MFN-125-80

SUBJECT: MARK I CONTAINMENT PROGRAM
ADDITIONAL INFORMATION ON VENT SYSTEM COMPRESSIBILITY
EFFECTS ON MARK I POOL SWELL

RESPONSE TO NRC QUESTIONS ON NEDE-24778-P,

Vent System Compressibility-Effects on Mark I Pool Swell

FIGURE 17. INTEGRATED MASS FLOW
CASE 2 - SUDDEN PRESSURE DROP AT
EXIT, DISTRIBUTED LOSSES IN SUBSCALE

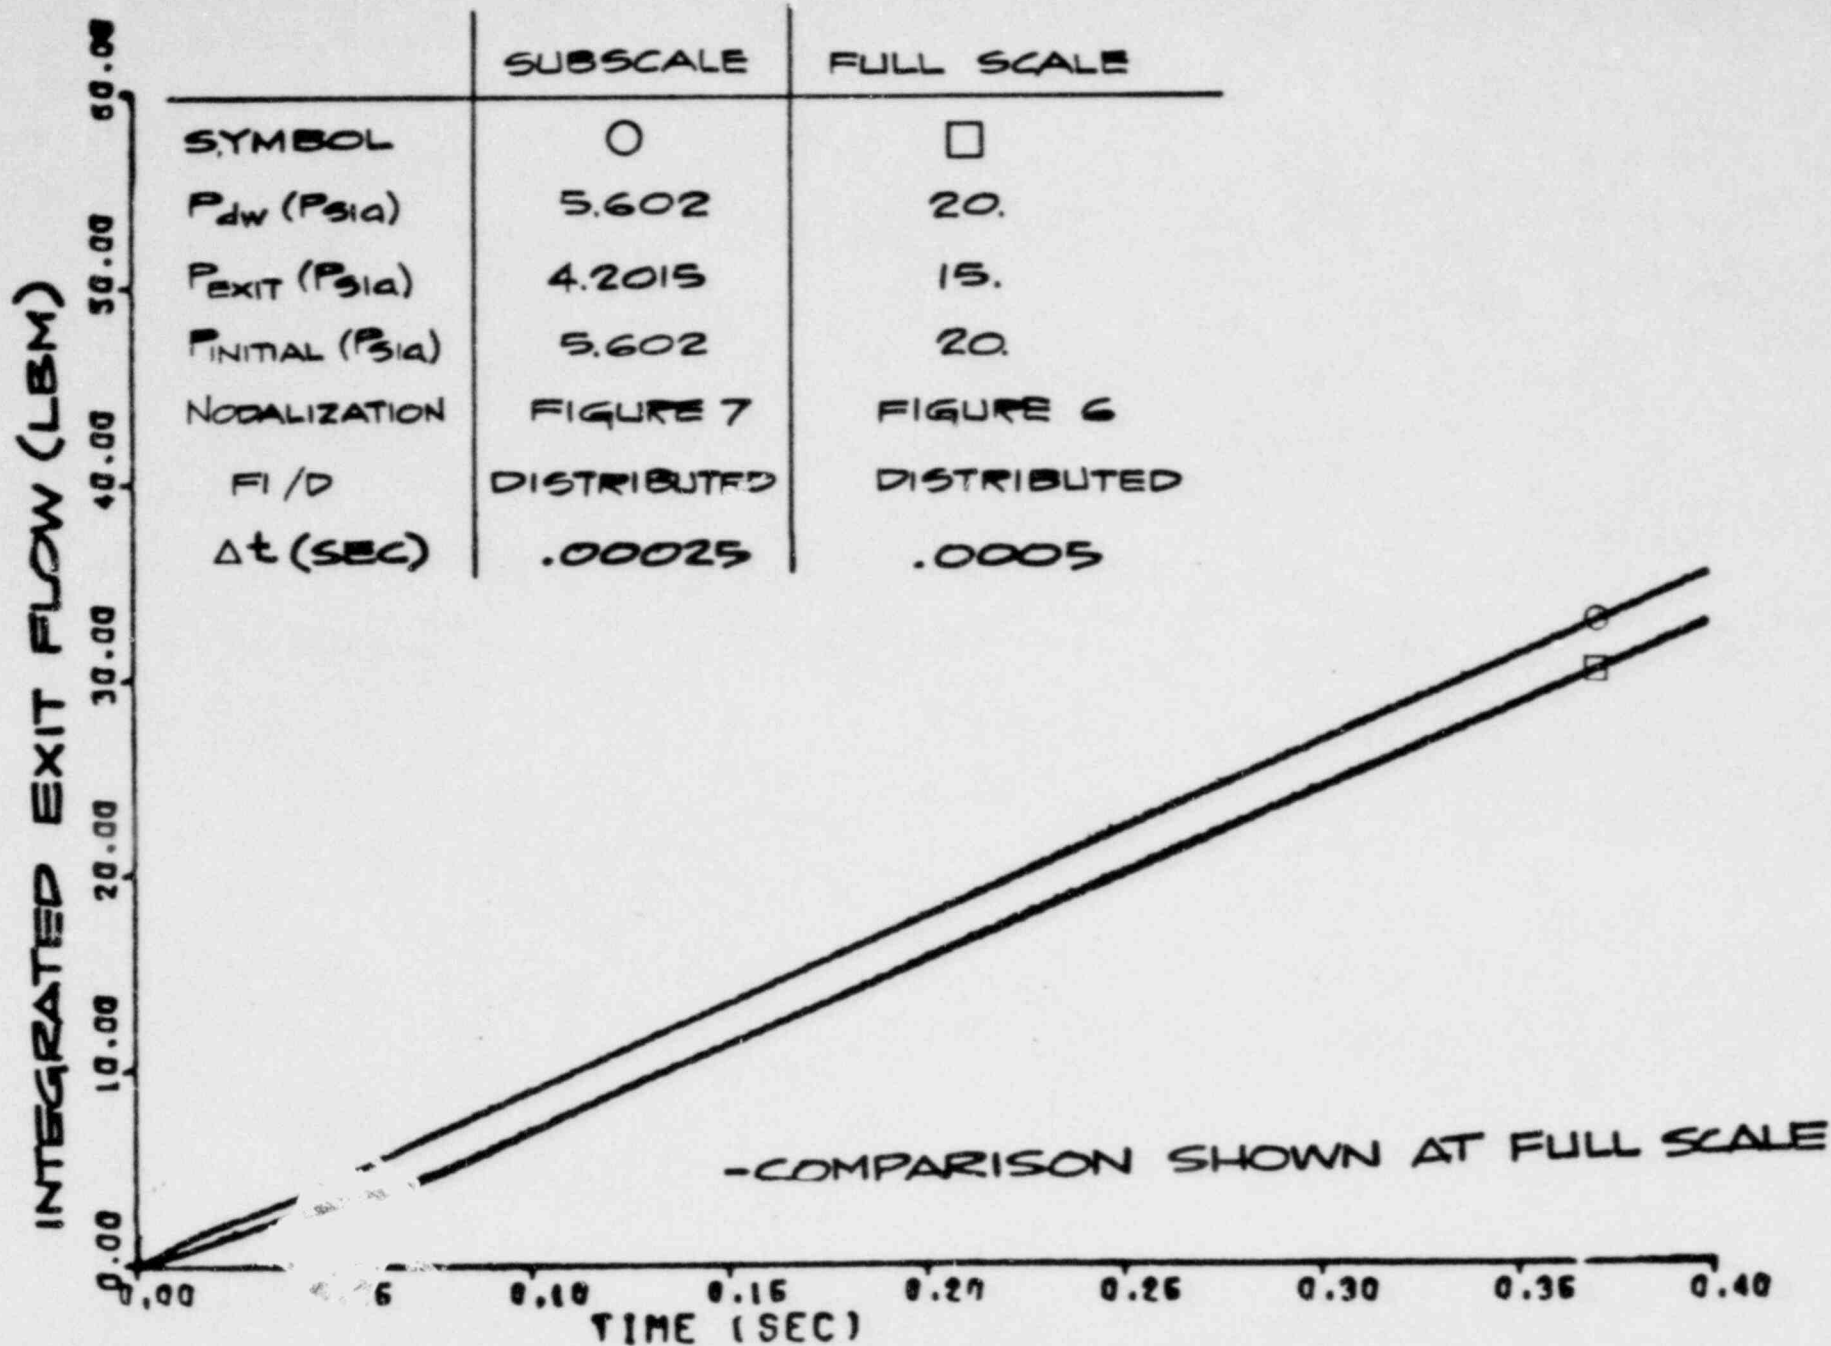
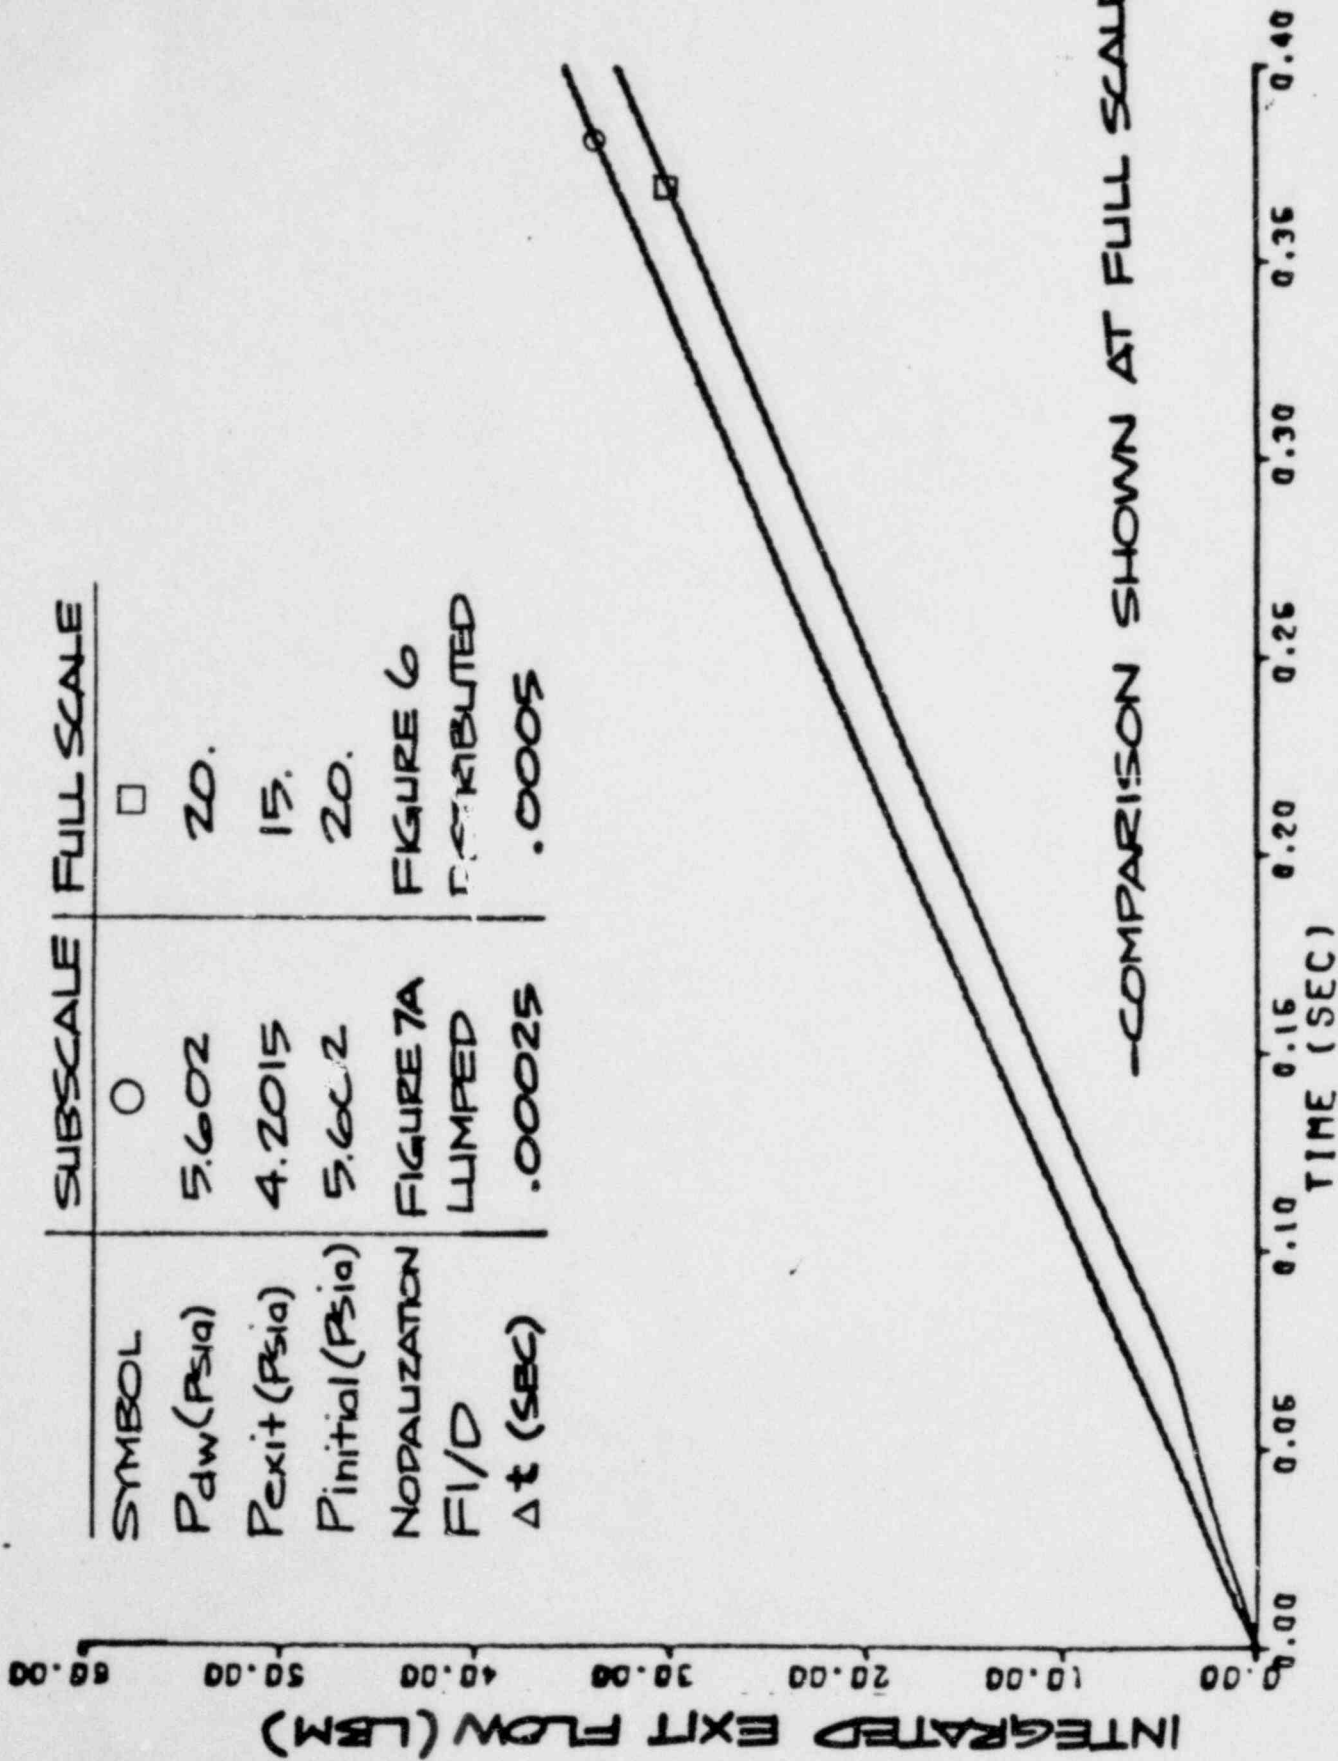
Results for Case 2, the sudden pressure drop at the exit, are shown in Figures 15 through 18. In general the mass defect due to compressibility was not altered by the new nodal system. The Reference 1 mass flow curves (Figure 5) have less fine structure than the new (Figures 15 and 16) results. This is due to the more complicated arrangement of losses and capacitances in the new (prototypical) nodalization. Rearrangement of major system losses relative to capacitances results in the differences between the curves in Figures 5, 15, and 16. The small steady state flow rate difference in Figure 16 between full scale and scaled quarter scale (slightly higher) arises from scaling vent system F1/D by $1/\lambda$. This approach

results in slightly conservative subscale vent system flow rates.
